SUBJECT: PORE SIZE OF FILTERS USED DURING TESTING OF DIESEL GENERATOR FUEL OIL (TAC NO. 71888)

RE: LIMERICK GENERATING STATION, UNIT 1

AMENDMENT TO FACILITY OPERATING LICENSE

SAFETY EVALUATION BY THE OFFICE OF NUCLEAR REACTOR REGULATION

DIESEL FUEL OIL FILTRATION CONFIGURATION  
FIGURE 1

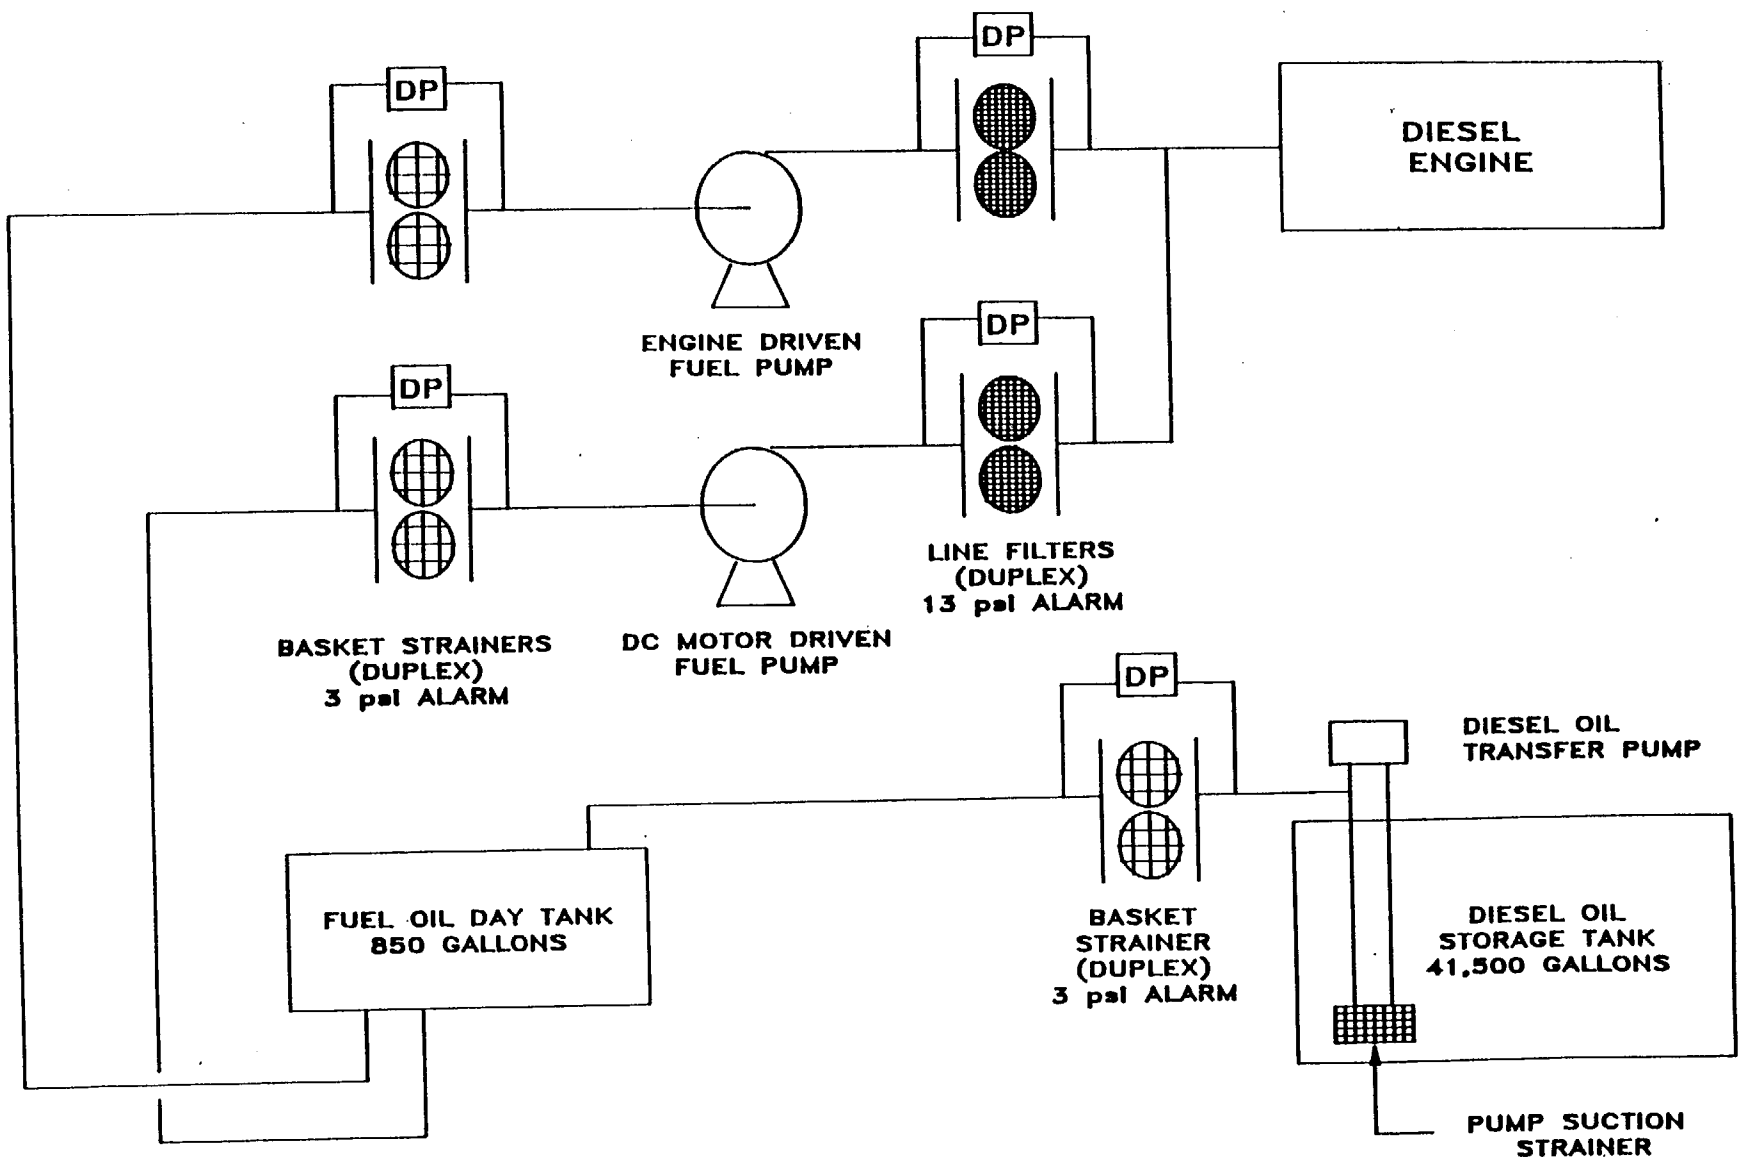
The Limerick plant has eight emergency diesel generators (EDGs) for the two units. The EDG fuel oil system is a safety-related system which provides on-site storage and delivery of EDG fuel oil for at least seven days of continuous operation of all EDGs operating at their full-rated load. Each EDG is provided with an independent fuel oil system. Each fuel oil system provides fuel oil to diesel engine fuel injectors and consists of a fuel oil storage tank, a fuel oil transfer pump, a day tank, an engine-driven fuel pump, a dc motor-driven auxiliary fuel pump, and associated piping, valves, strainers, filters and instrumentation (See Figure 1).

2. The fuel oil transfer pumps are equipped with a suction strainer to prevent the entrance of any large particles or debris.
3. Any particulates passing through the fuel oil transfer pump would be trapped by the strainers and filters located between the fuel oil transfer pump discharge and the diesel engine. Basket strainers are located on the fuel oil day tank supply piping and one on the suction of both the engine-driven fuel oil pump and the dc motor-driven fuel oil pump.

4. These filters and strainers are equipped with differential pressure indicators and alarms to notify the operators of impending clogging. The basket strainers will alarm when the pressure differential exceeds 3 psid. Due to the higher pressure drop present for fine fuel oil filtration in the line filters, the alarms on these filters will sound when the pressure drop exceeds 13 psid. Operating history of the line filters has resulted in the observation that a rise in the differential pressure across the filters from 1 psi to 4 psi occurs during an 18-month reactor fuel cycle at LGS. This 18-month cycle includes a monthly EDG run for surveillance testing and numerous other EDG runs for various reasons. Operating history of the strainers indicates a negligible rise in differential pressure during an 18-month reactor fuel cycle. These alarm settings provide ample time for the operator to manually switch to the other filter or strainer element before the operability of the EDG is compromised.
